**SHEARON HARRIS NUCLEAR POWER PLANT, UNITS 2 AND 3
DOCKET NOS. 52-022 AND 52-023
SUPPLEMENT 1 TO RESPONSE TO REQUEST FOR ADDITIONAL INFORMATION LETTER
NO. 018 RELATED TO VIBRATORY GROUND MOTION**

**Shearon Harris Nuclear Power Plant Units 2 and 3
Response to NRC Request for Additional Information Letter No. 018 Related to SRP
Section 02.05.02 for the Combined License Application,
dated September 25, 2008**

Figure RAI 2.5.2-4-1 Intensity distribution for the January 8, 1817 earthquake (Bollinger and Visvanathan, 1977)

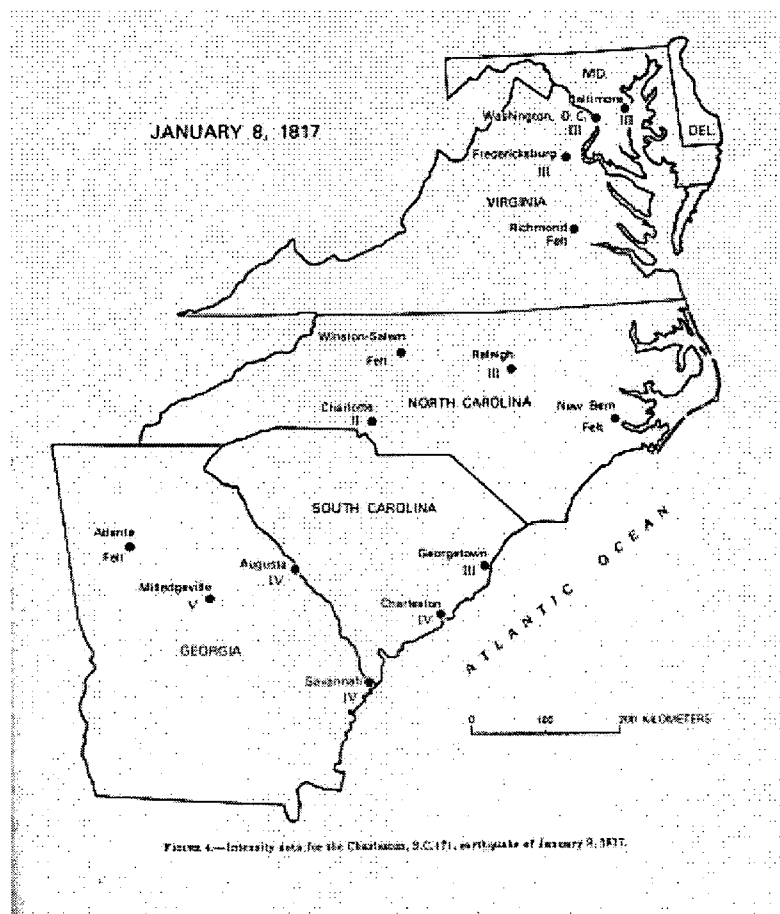
Section 2.5.2.1.2 describes the uncertainty associated with the location of one of the significant earthquakes, the January 8, 1817, event with an estimated magnitude $m_b = 5.0$, identified in the HAR earthquake catalog. The EPRI catalog places this event about 145 km to the west of the HAR site. However, the location was significantly revised by later studies. The NCEER-91 (National Center for Earthquake Engineering Research) Catalog places this event off shore about 1000km east of the HAR site. Yet, the USGS catalog places it near Charleston, about 300 km south of the HAR site. You used the USGS location in your safety analysis. However, this location appears to be in conflict with the earthquake's felt area reports. While the felt area from this earthquake, as reported in Section 2.5.2.1.2, stretches from Milledgeville, GA, to Baltimore, MD, this reassigned location near Charleston is significantly closer to the southern end of the felt area. The northern end of the felt area is about 800km away from this location. Please provide further justification for relocating this event in the Charleston area and discuss how you account for this apparent discrepancy between the epicenter location and the felt area reports. Given the uncertainty in the location of this event, also provide a discussion about the potential impact on hazard at the HAR site, if the location were to be at the approximate center of the felt area, as it is normally observed in felt area/earthquake location studies.

As discussed in FSAR Subsection 2.5.2.1.2, the location of the January 8, 1817 earthquake is highly uncertain.

- The current location in the USGS catalog is at Charleston, SC with a reference to Stover and Coffman (Reference 2.5.1-279). The location in Stover and Coffman (Reference 2.5.1-279), 32.9°N, 80°W, is attributed to Bollinger and Visvanathan (1977). Figure RAI 2.5.2-4-1 shows the map of intensity data presented in Bollinger and Visvanathan (1977), who list the event location as "Charleston".

- The EPRI-SOG (Reference 2.5.2-201) location, 36°N, 80.2°W, is roughly in the middle of the felt area.
- MacCarthy (1957) indicates an earthquake "felt in the Winston-Salem," NC area on that date, MacCarthy (1961) indicates that "the epicenter appears to have been quite close to Charleston," and MacCarthy (1964) indicates that the event's "epicenter was probably somewhere in the Carolinas." It should be noted, however, that the felt reports shown on Figure RAI 2.5.2-4-1 are generally low in North Carolina and higher in South Carolina and Georgia.

- The NCEER91 catalog (Reference 2.5.2-205) lists the earthquake location as 33°N 70°W. FSAR Subsection 2.5.2.1.2 incorrectly states that this is likely an error. John Armbruster was contacted concerning this location, and he indicated that he placed the

Comparison of EPRI (2004) Median
Ground Motion Models with
More Recent Models
FIGURE 2.5.2-221 (Revised)

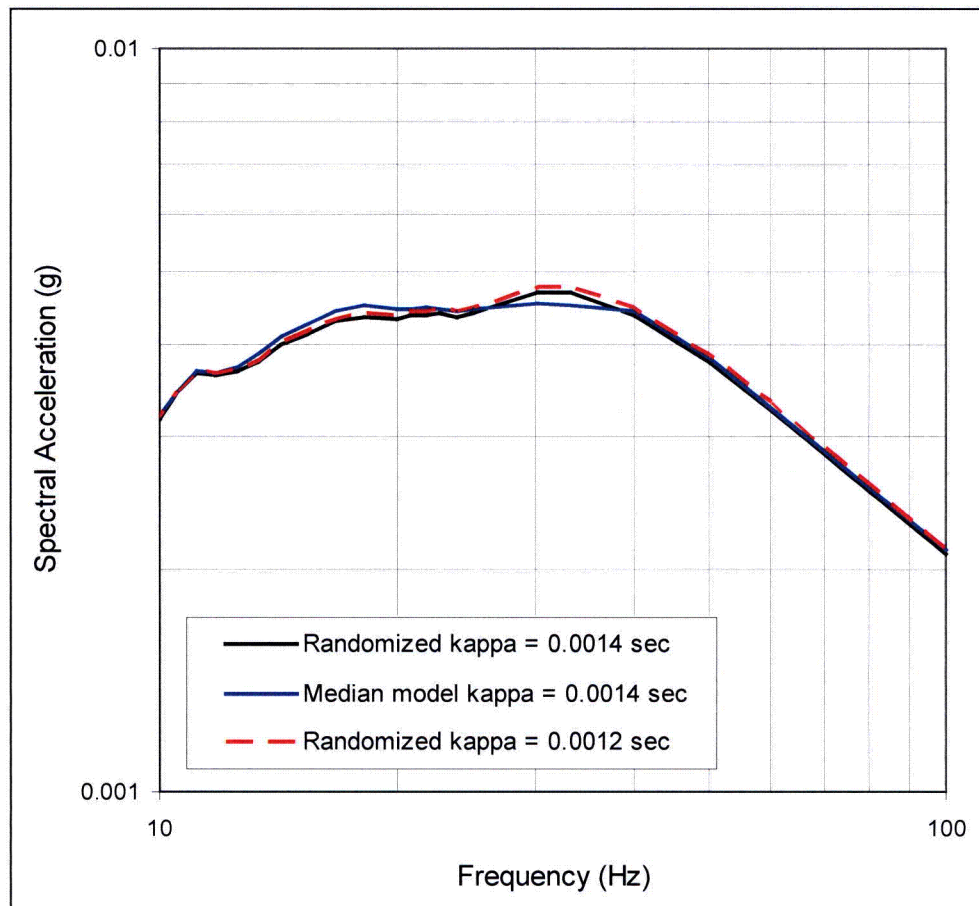
In Section 2.5.2.4.2.1, you compared the impacts of new ground motion models proposed since the publication of the EPRI 2004 models. However, you did not include a 2005 Eastern North America ground motion prediction model developed by Tavakoli and Pezeshk (BSSA, 2005, v.95[6], 2283-2296) in your sensitivity analysis. Please provide comparative charts showing the differences between the ground motions calculated with this new model and the other models used in the HAR study.

FSAR Figure 2.5.2-221 will be modified in a future revision to include a comparison of the Tavakoli and Pezeshk (Reference RAI 02.05.02-11 01) ground motion model with the EPRI (Reference 2.5.2-248) ground motion models. The Tavakoli and Pezeshk (Reference RAI 02.05.02-11 01) model is a hybrid ground motion model; Revised Figure 2.5.2-221 (attached) compares this model with the EPRI (Reference 2.5.2-248) ground motion models for Cluster 3. The Tavakoli and Pezeshk (Reference RAI 02.05.02-11 01) model predictions generally fall within the range of the EPRI (Reference 2.5.2-248) cluster 3 medians except for 1 Hz ground motions from small magnitude events at short rupture distances. As presented in Subsection 2.5.2.4.4, small-magnitude earthquakes at close distances have a small contribution to the low-frequency hazard.

Median Surface Response Spectra Used to
Assess "scattering κ " for the HAR 2 Profile
RAI 2.5.2-14 Figure 1

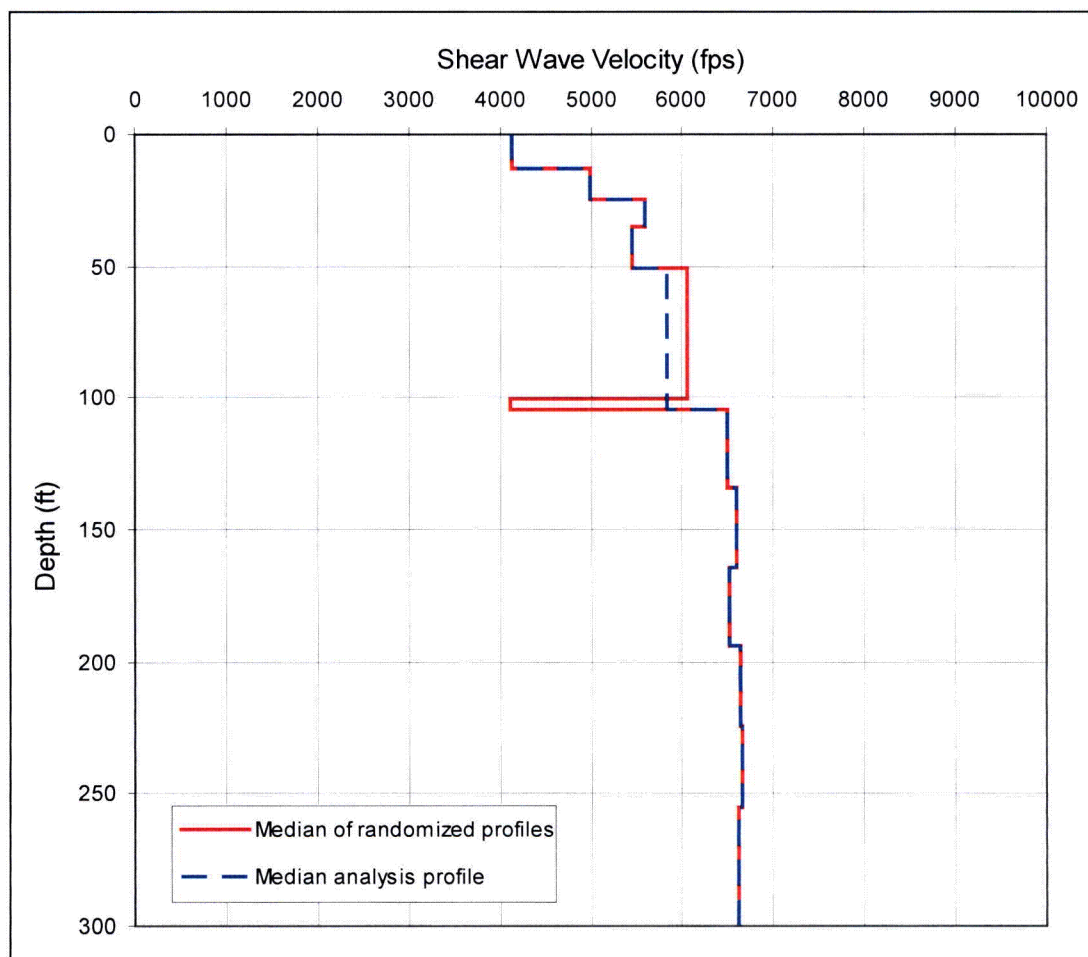
In section 2.5.2.5.1.4, you stated that "The κ values are reduced by an additional 0.0002 second to account for the effects of scattering due to randomization of the velocity profiles". Please explain the basis for this reduction value of 0.0002 sec. Is this number based on any scientific study results, or is it a best estimate value?

First, site response analyses were conducted using the 60 randomized velocity profiles for HAR 2 shown on FSAR Figures 2.5.2-264 and 2.5.2-265. These calculations were performed using a very low level of input motion in order to maintain linear behavior. Also, the material damping in the rock layers was developed using the lower value of site κ of 0.0014 seconds to maximize the influence of scattering on the site response. The median of the response spectra for the computed surface motions is shown on Figure RAI 2.5.2-14-1. Then a second set of site response calculations was performed using a single velocity profile equal to the median of the randomized velocity profiles. This profile is shown on Figure RAI 2.5.2-14-2. The scattering effect of the lower velocity zone at a depth of 100 ft was accounted for by replacing that layer and the layer above by a single layer with an equivalent uniform shear wave velocity. The response of this profile was computed using the full set of rock motions and the median response spectrum for the surface motions was obtained. This spectrum, shown on Figure RAI 2.5.2-14-1, is slightly higher at frequencies above 20 Hz than the median spectrum obtained using the randomized profiles. The difference is attributed to the scattering effect of the velocity contrasts in the velocity profiles. The amount of "scattering κ " was assessed by repeating the analyses using the randomized profiles, gradually reducing the value of κ used to obtain material damping in the rock layers until the median response of the randomized profiles reached the same level as that for the single median profile at high frequencies. This result was achieved with a value of κ equal to 0.0012 seconds, as shown on Figure RAI 2.5.2-14-1.

Probability that CAV exceeds 0.16 g
seconds for VS30 of 1548 m/sec
RAI 2.5.2-15 Figure 1

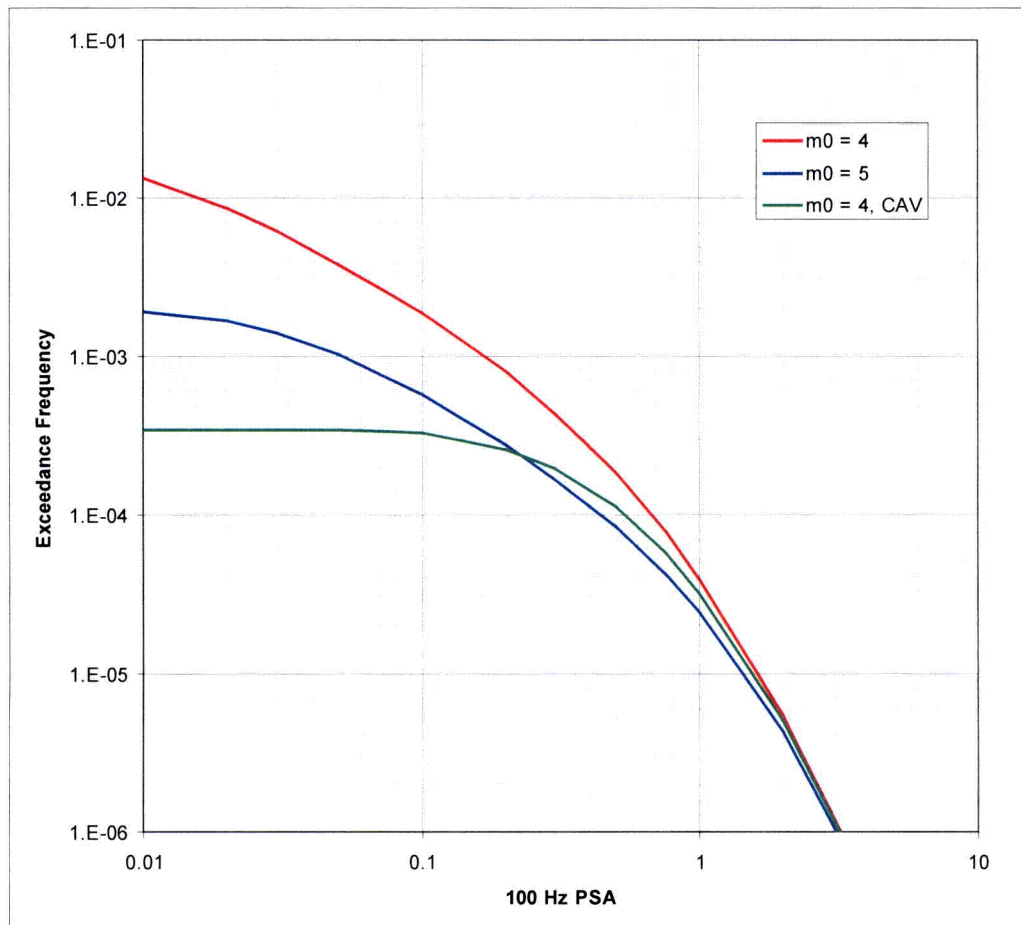
Section 2.5.2.6 provides a table (Table 2.5.2-221) showing the spectral acceleration ratios computed with CAV and no-CAV filters. The table lists ratios greater than 1.0 for the 10^{-6} Probability of Exceedance values at frequencies of 10, 25, and 100Hz. Please provide an explanation of why the surface UHRS with CAV would produce higher amplitudes in spectral acceleration.

The reason that the calculation of hazard using the CAV filter produces slightly higher hazard at low exceedance frequencies is due to the contribution from earthquakes smaller than the minimum magnitude used in the non-CAV hazard calculation. RAI 02.05.02-15 Figure 1 shows values of the probability that the value of CAV will exceed 0.16 g-seconds as a function of earthquake magnitude and peak acceleration level. These values are computed using the EPRI (Reference 2.5.2-271) CAV model for a V_{S30} of 1548 m/sec, the value for the GMRS horizon at the HAR site. These results show that for higher peak acceleration levels associated with low exceedance frequencies, the probability that small magnitude earthquakes can produce CAV greater than 0.16 g-seconds is well above 0. Thus, these earthquakes would contribute to the site hazard.
